Proposal for correction to ECE/TRANS/WP.29/GRB/2016/2

This proposal was made after consultations with OICA in order to provide for consistency in terminology used and to match the drawing in Annex 4 with the modified provisions. The added word “warning“ is underlined. The deleted text is marked strikethrough.

Annex 2, the text after “Model A”, amend to read:

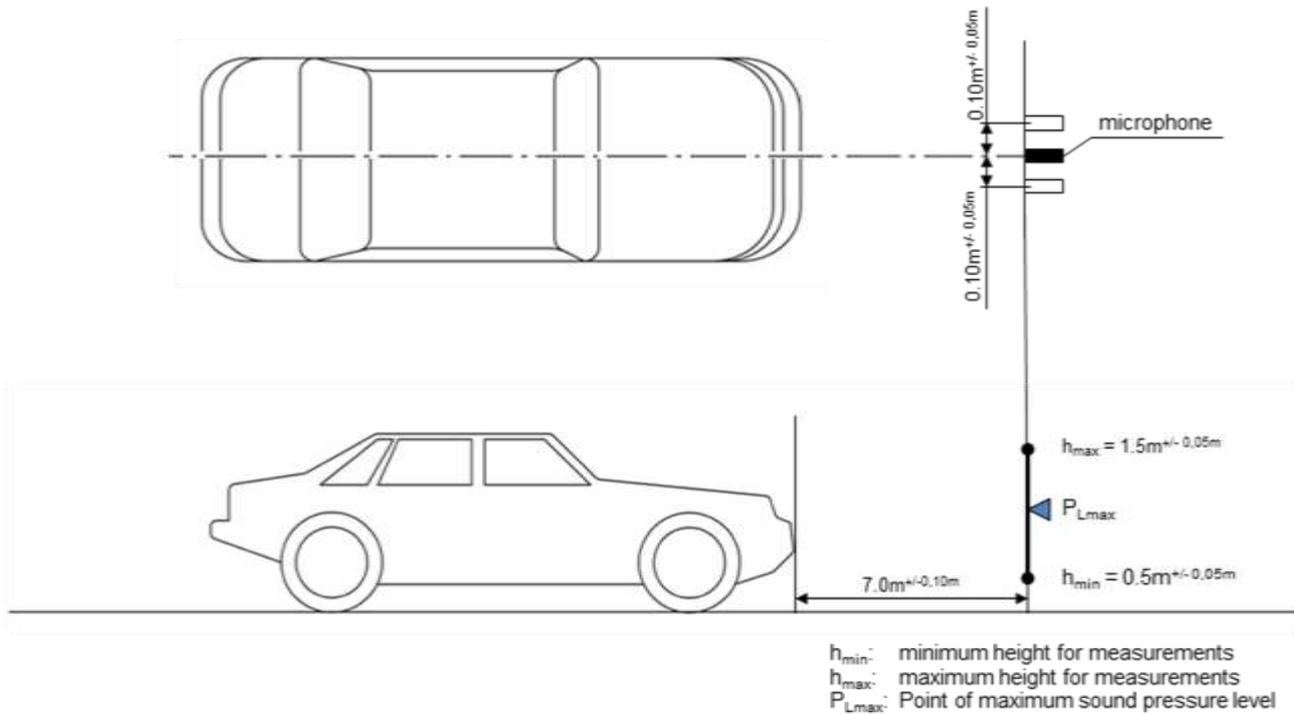
“ The above approval mark affixed to a vehicle indicates that, pursuant to Regulation No. 28, this vehicle type has been approved in the Netherlands (E 4), with regard to its audible warning signals. **The first two digits of the approval number indicate that Regulation No. 28 was in its original form.**”
